The Town of Hilton Head Island
Design Review Board Special Meeting
Wednesday, May 27, 2020 – 9:00 a.m.
AGENDA

Town of Hilton Head Island
Design Review Board
March 10, 2020 at 1:15 p.m. Regular Meeting
Benjamin M. Racusin Council Chambers

ELEVATIONS
A2.1

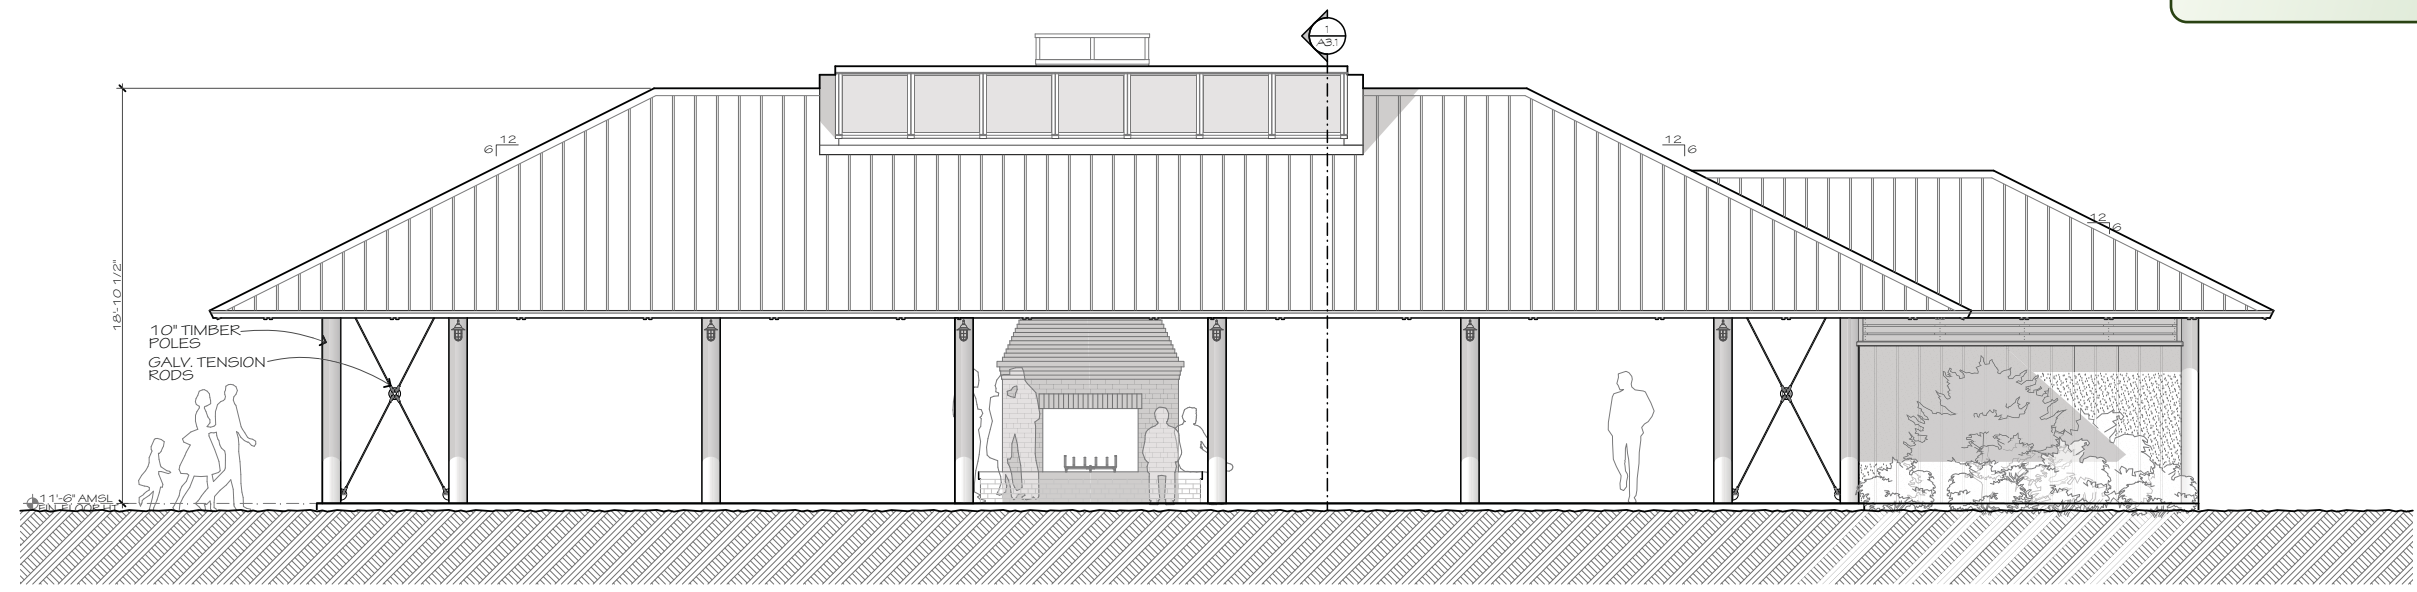
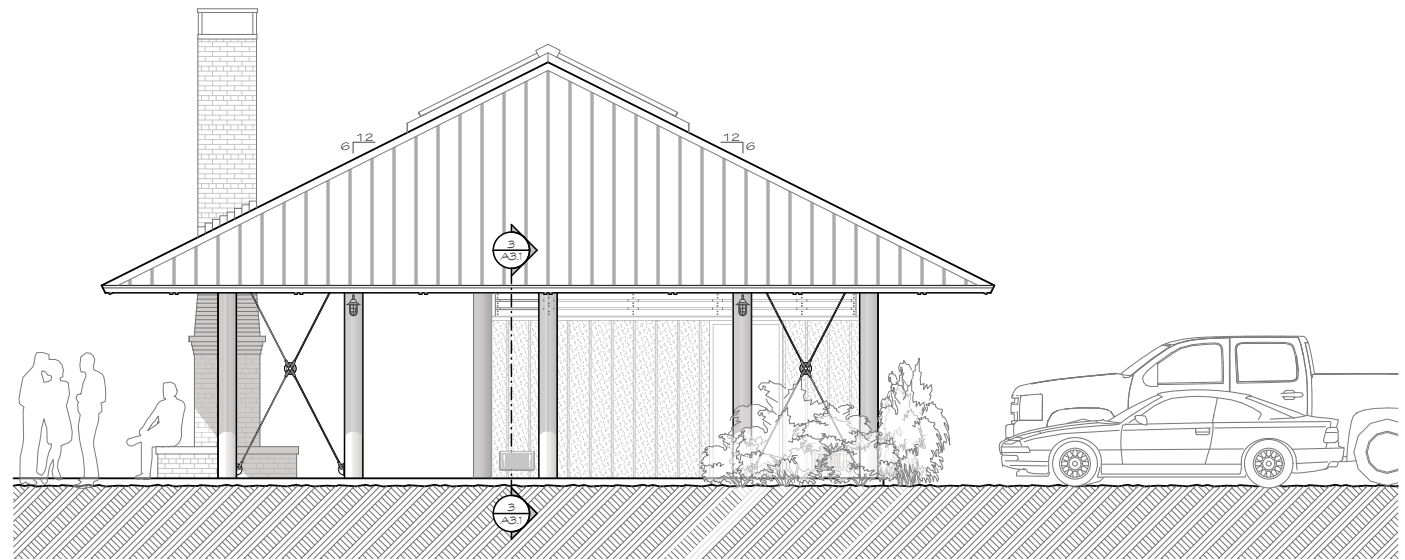
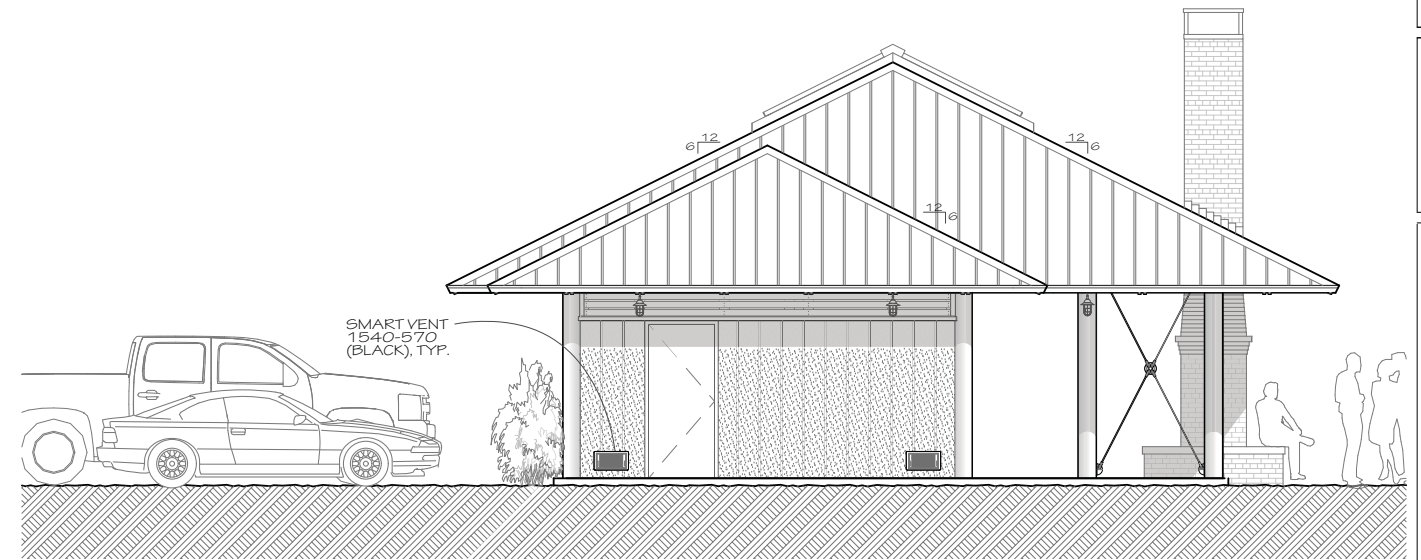
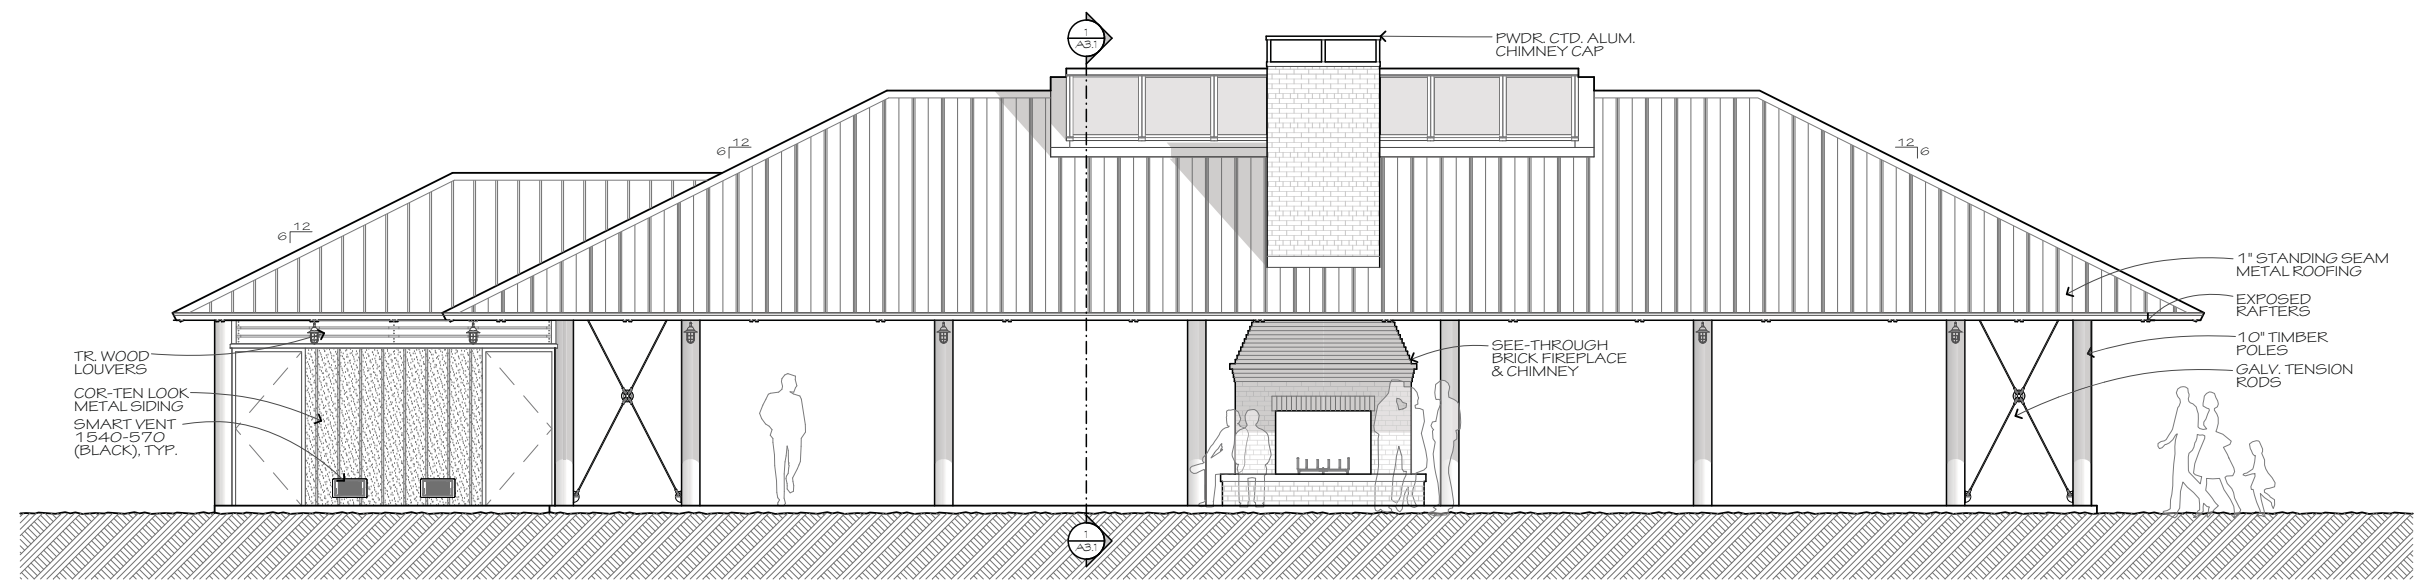
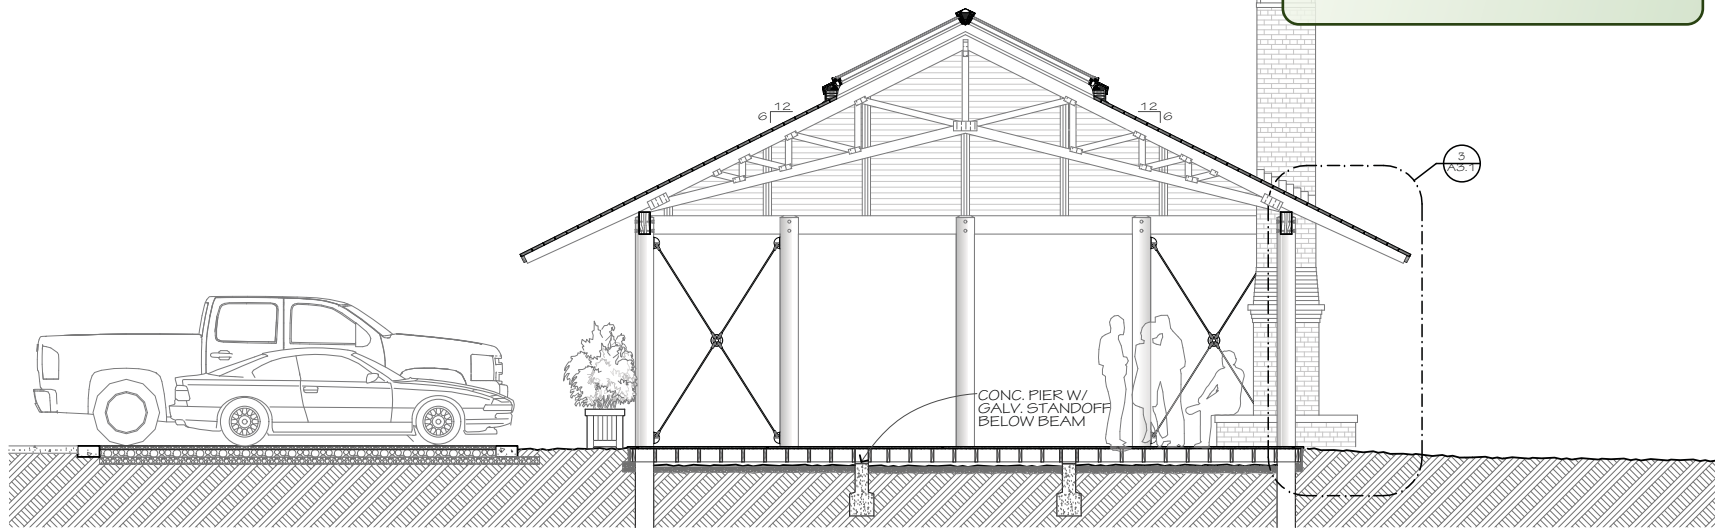
1. Applicant shall make suggestions to change, rework and or otherwise obscure the galvalume conduit and sprinkler system for review by staff and one DRB member.
2. Poles, trusses and louvers shall be finished per DRB approved plans.
3. Storage furniture shall be finished to match the structure.
